CITY OF ALBUQUERQUE

Re: Central Apartments
1020 Central Ave SW
Traffic Circulation Layout
Architect's Stamp 01-21-2021 (K13-D080; BP-2020-43281)

FILE TITLE: ARCHITECTURAL SITE PLAN & TRAFFIC CIRCULATION LAYOUT

AS-1
TCL-1

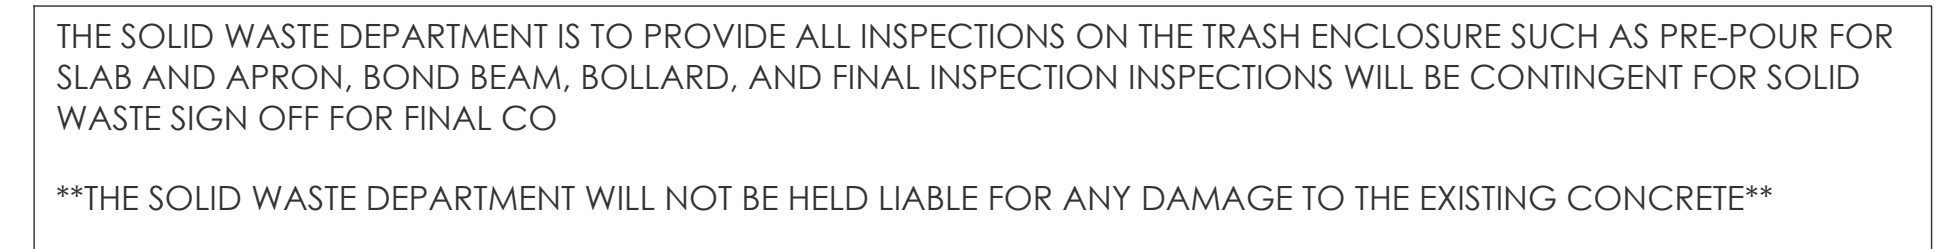
- "Emergency Access Only" signs for the west entrance. (These were mentioned in the response letter to the TCL comments but were not shown on the actual plan submittal.)
- Sufficient dimensioning shall be provided behind the planter for wheelchair access at the northeast corner of the parking lot. (An overall sidewalk dimension was shown, but there was no dimension around obstacles.)
- Due to various lot lines crossing the parking lot, a shared parking and access easement is required.
